Staff Report

Date: March 4, 2026
To: **Devens Enterprise Commission**
From: Neil Angus, Director
RE: **Adams Circle Reconstruction and Infrastructure Upgrades**

RE: Nitsch Project #9419
Adams Circle
Roadway Reconstruction &
Utility Improvements
Stormwater Review
Devens, MA

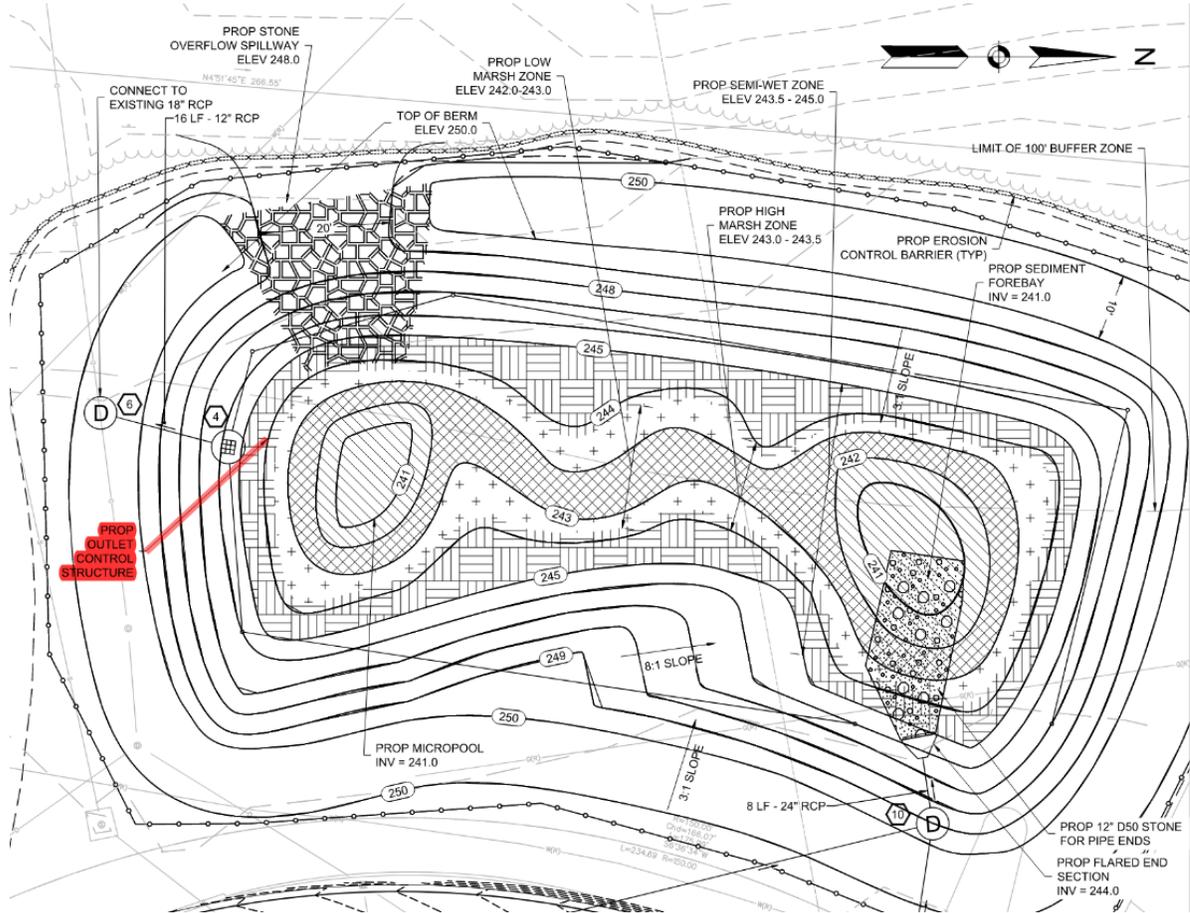
The detail on Sheet 31 specifies 3 inches of filter course, whereas the SMS requires 12 inches. The Applicant should review and address this standard.
